STATE OF NEBRASKA
DEPARTMENT OF TRANSPORTATION
ADDENDUM NO. 3
AND
ELECTRONIC BIDDING SYSTEM
AMENDMENT NO. 3
PROJECT NO. NH-75-2(128)
CONTROL NO. 21209
CALL NO. 200
US-75, MURRAY - PLATTSMOUTH
LETTING DATE: NOVEMBER 19, 2020

(R1) ADDED SHEET

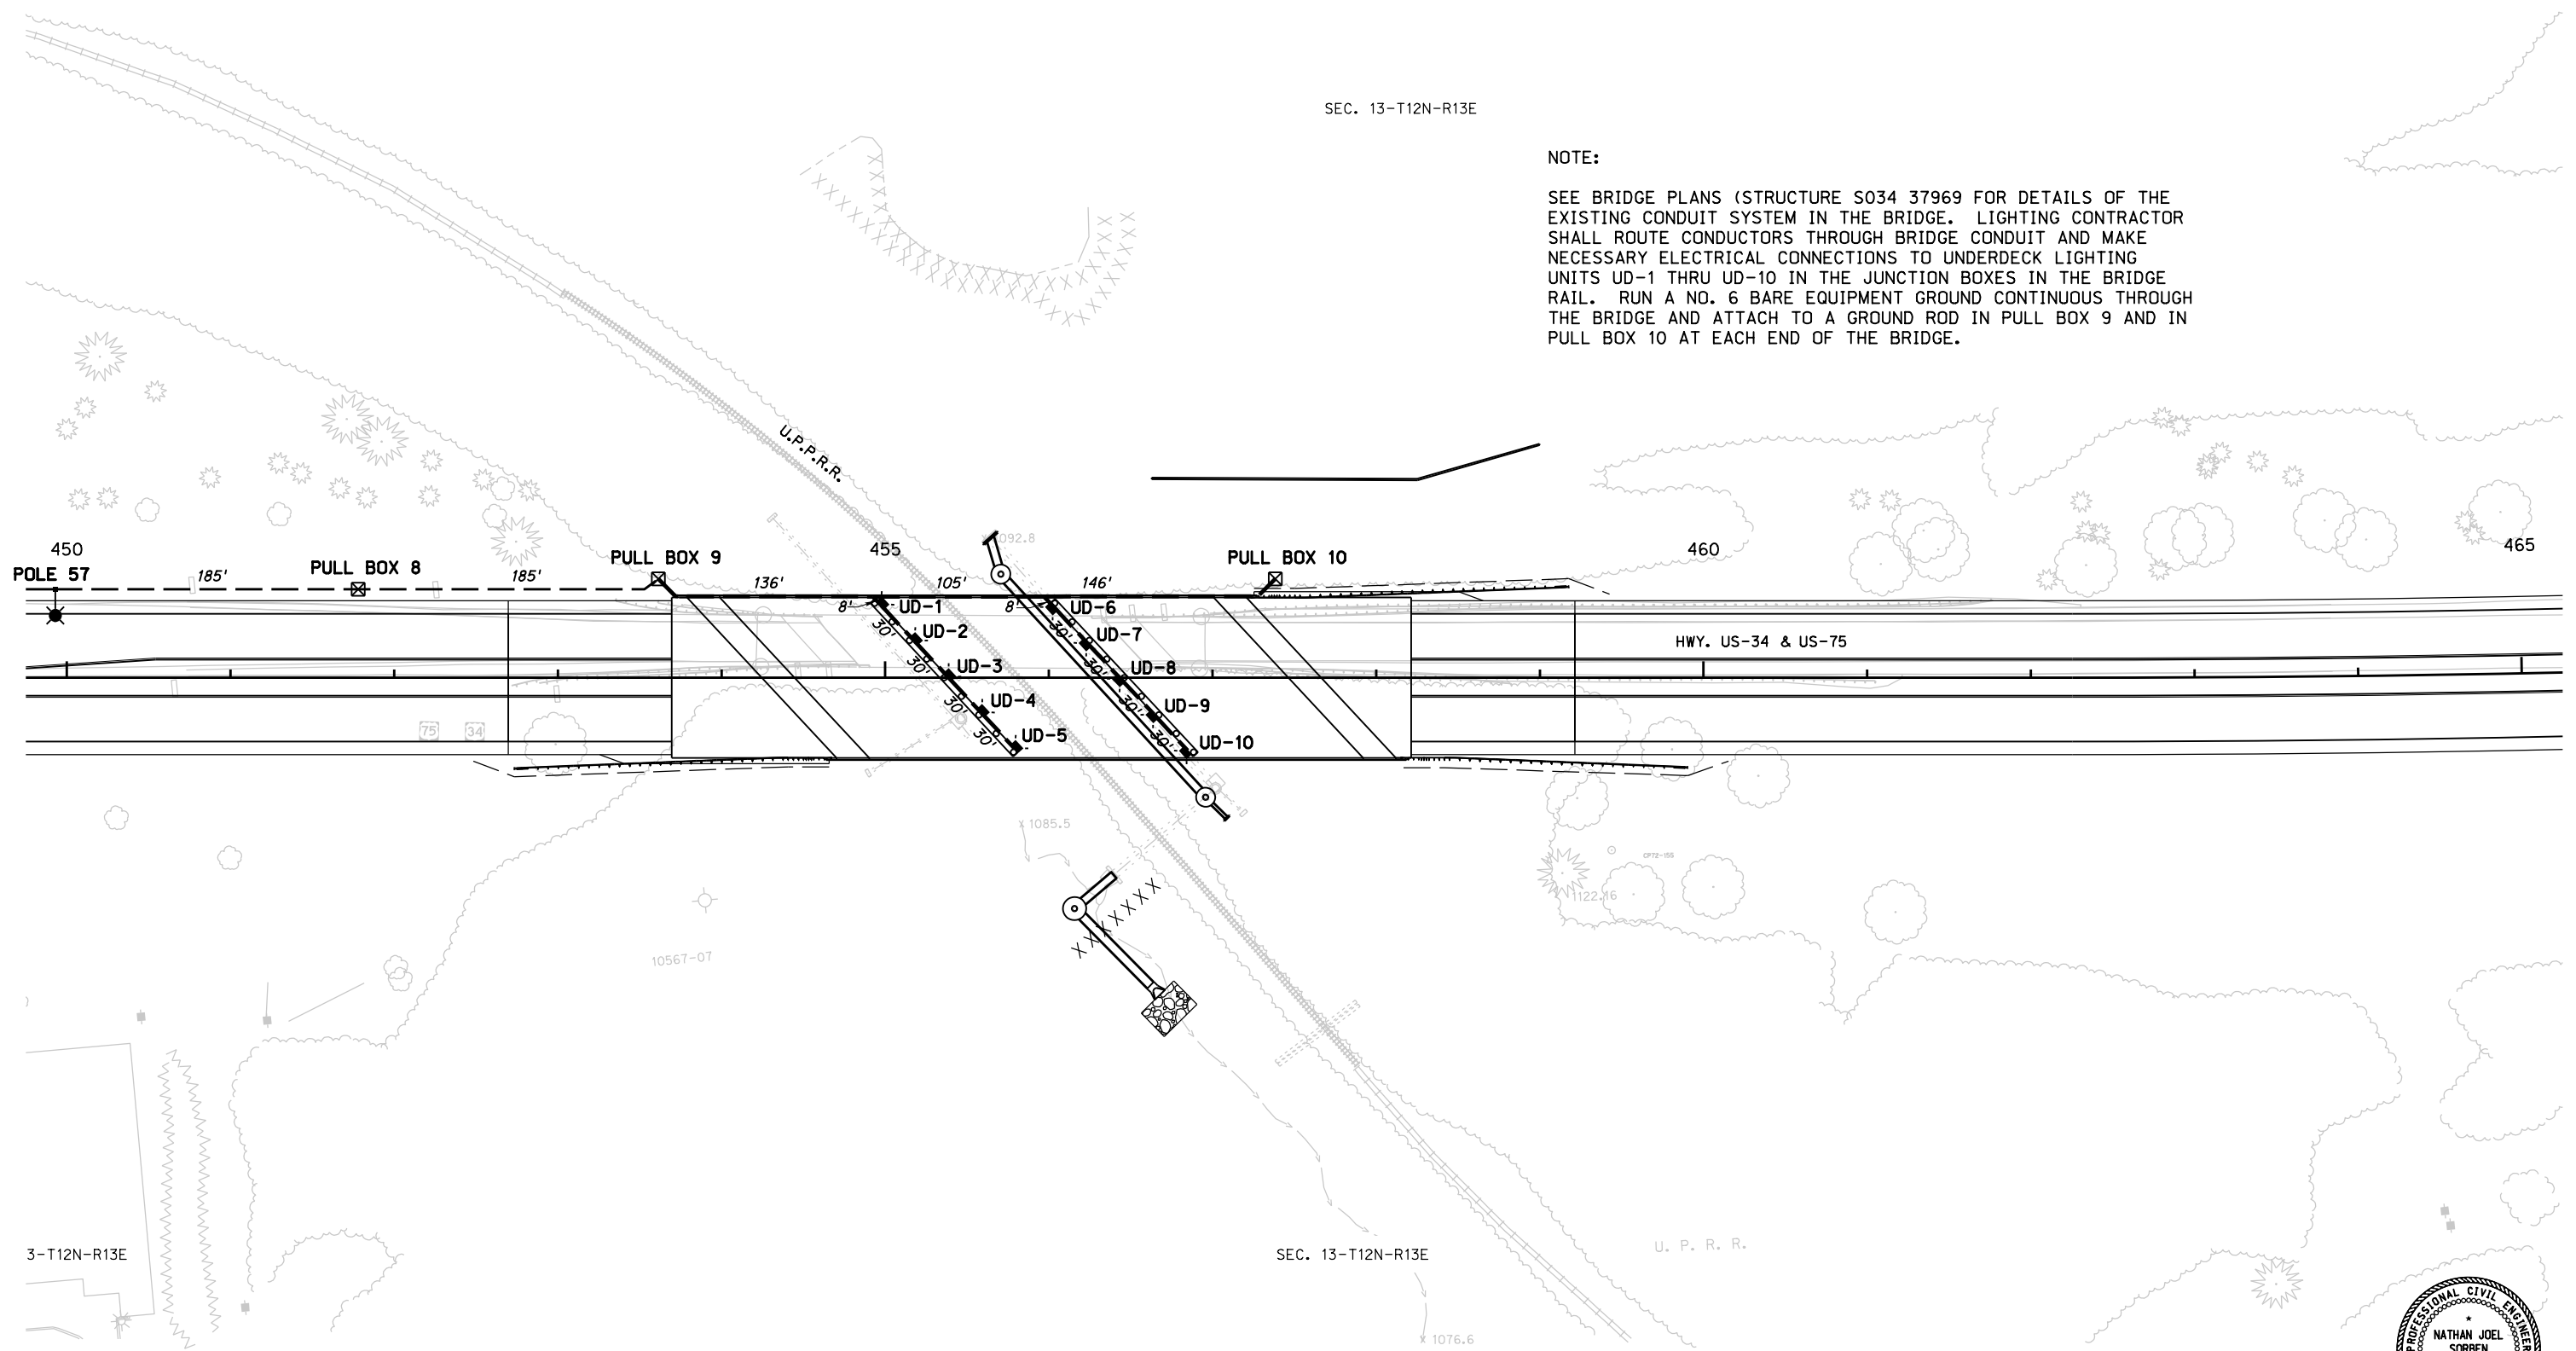
The plans are amended to include added sheets M13 and M14 as depicted on the attached sheets.

SEE BRIDGE PLANS (STRUCTURE S034 37969 FOR DETAILS OF THE EXISTING CONDUIT SYSTEM IN THE BRIDGE. LIGHTING CONTRACTOR SHALL ROUTE CONDUCTORS THROUGH BRIDGE CONDUIT AND MAKE NECESSARY ELECTRICAL CONNECTIONS TO UNDERDECK LIGHTING UNITS UD-1 THRU UD-10 IN THE JUNCTION BOXES IN THE BRIDGE RAIL. RUN A NO. 6 BARE EQUIPMENT GROUND CONTINUOUS THROUGH THE BRIDGE AND ATTACH TO A GROUND ROD IN PULL BOX 9 AND IN PULL BOX 10 AT EACH END OF THE BRIDGE.

**CONNECTIONS IN JUNCTION BOX
 (TYPICAL)**

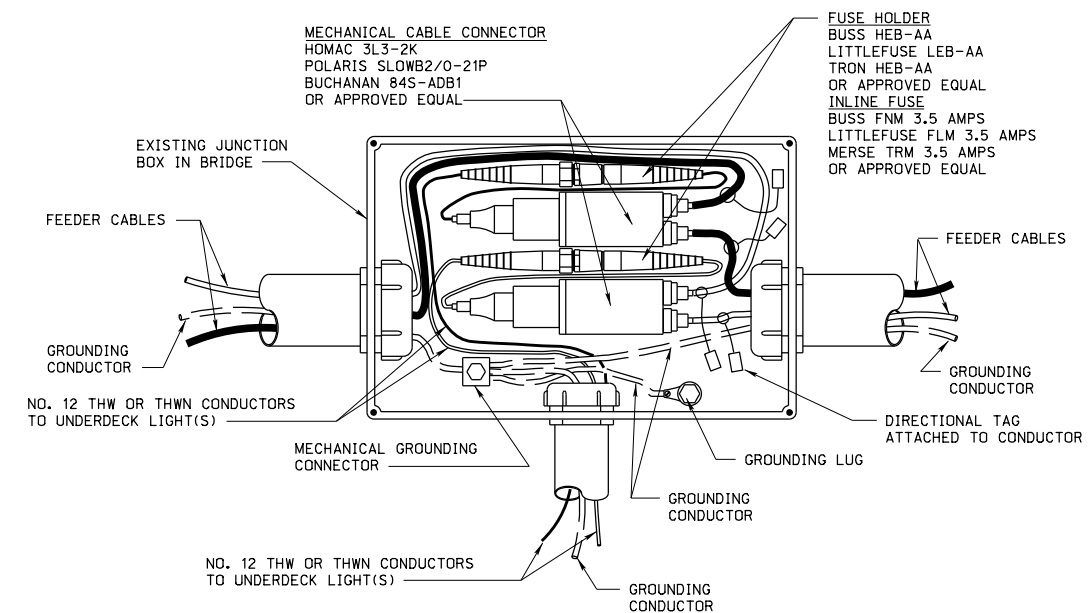
FURNISH AND INSTALL UNDERDECK UNITS OF THE TYPE SHOWN IN THE PLANS. EXCEPT FOR A TOTAL OF APPROXIMATELY 6 FT. OF 3/4" LIQUID TIGHT FLEXIBLE METAL CONDUIT, THE CONDUIT SYSTEMS TO THE UNDERDECK LIGHTS ARE EXISTING. THE CONTRACTOR WILL FURNISH AND INSTALL THE LIQUID TIGHT CONDUIT BETWEEN THE STUBOUT IN THE UNDERSIDE OF THE BRIDGE DECK AND THE STUBOUT IN THE TOP OF THE PIER CAP.

UNDERDECK UNITS WILL BE FED FROM THE STREET LIGHTING CIRCUIT IN THE BRIDGE CURB. TAP THE STREET LIGHTING CIRCUIT IN THE EXISTING JUNCTION BOXES IN THE BRIDGE CURB.

INSTALL CONDUCTORS IN THE EXISTING 3/4" CONDUIT TO THE UNDERDECK LUMINAIRES. PROVIDE APPROVED WEATHERPROOF IN-LINE FUSE HOLDERS WITH FUSES TO THE UNDERDECK CIRCUITS. USE NO. 12 TYPE THWN STRANDED COPPER CONDUCTORS FOR THE PHASE CONDUCTORS AND NO. 12 STRANDED COPPER WIRE (BARE OR GREEN INSULATION) FOR THE EQUIPMENT GROUNDING CONDUCTOR. FUSE THE CIRCUITS IN THE EXISTING JUNCTION BOXES.
